Bryant Planning Commission Meeting

Date: November 14, 2024 - **Time:** 6:00 PM

7. Hillcrest Addition Subdivision - 3927 Springhill Road - Preliminary Plat

Tim Lemons - Requesting Preliminary Plat Approval

Date: JULY 9, 2024
Scale: 1" = 20'
Drawn By: B. Judd
Project No. 24-018
File: 05_Hillcrest Pond
Sheet: 5 of 10

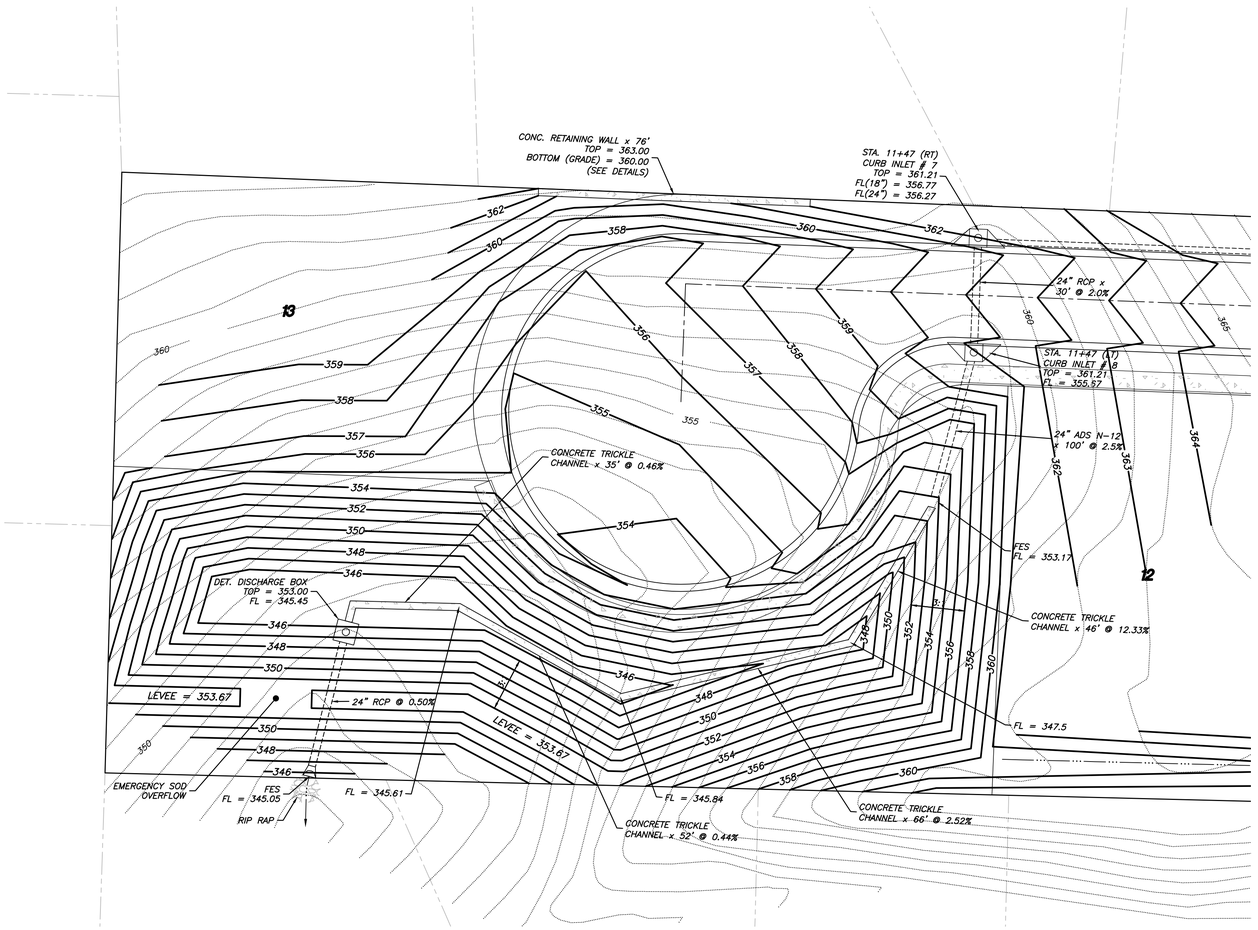
3. Sheet 5 of 10, show inlet numbers. ***Added as requested.***
4. Sheet 5 of 10, Is the top 4" slot all the way around the box beneath the top? ***Yes. I have added additional information on this detail to better represent this item.***

Project No.: 24-018
Date: SEPTEMBER 20, 2024
File: 03_Hillcrest Culvert
Scale: 1" = 50'
Drawn By: B. Judd
Sheet: 3 of 10

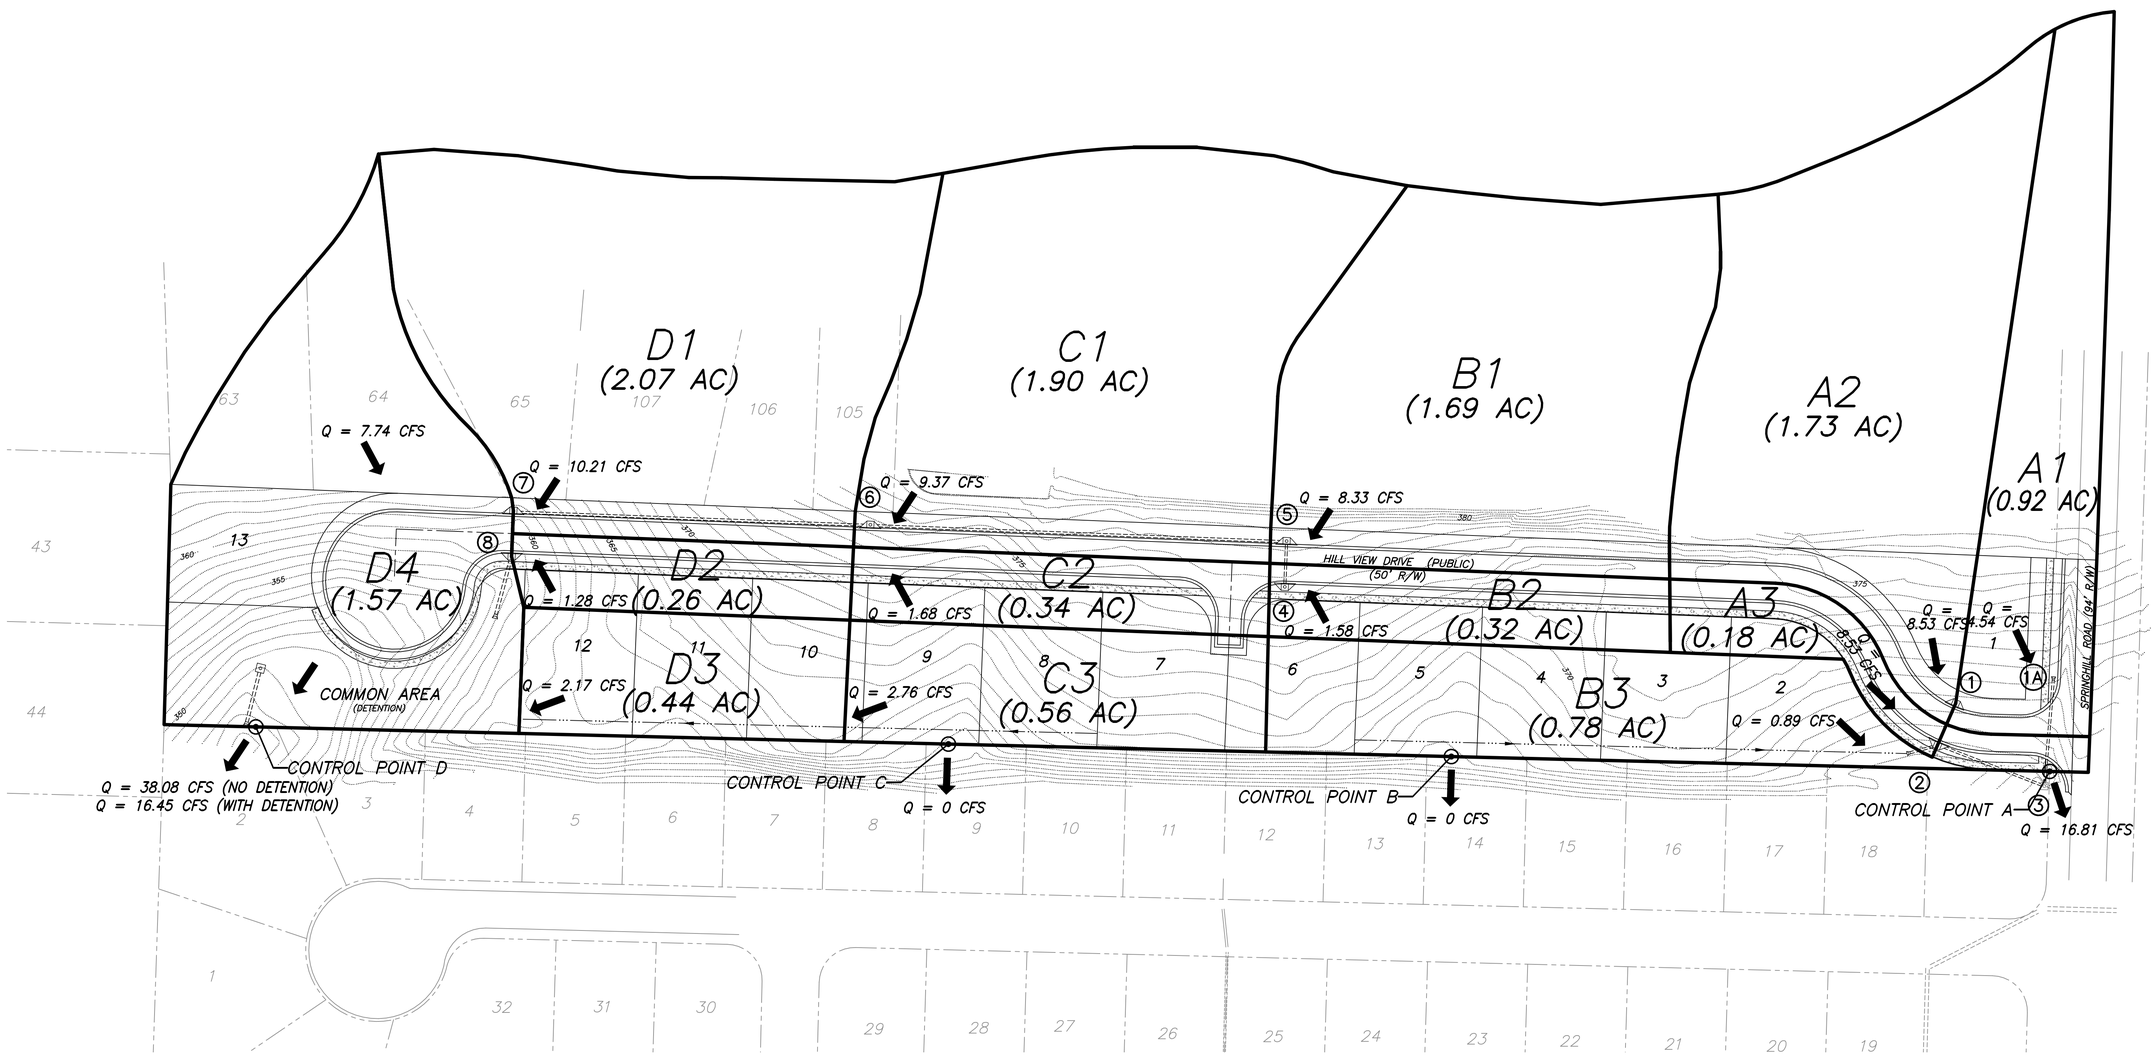
1. Sheet 3 of 10 shows the existing18" culvert stopping just behind the curb of the half-street improvements. Since the existing ditch will be graded over, it appears that this pipe should be extended to the north and pick up flow from the north. ***We will need to consult the owners as to when the half street improvements will be constructed. If the City and the Owner agree to an in leu of cost clause, the pipe will need to end in the vicinity of where it is shown on the existing plans. We are willing to discuss this with staff.***

2. Sheet 3 of 10, show the existing ditch & culvert to the south of JB#3 along Springhill Road. Show details on how the outlet looks and how the flow will be handled to the south. ***We will be matching the existing half street road improvements from our planned intersection, to the South. This has been added to this sheet.***
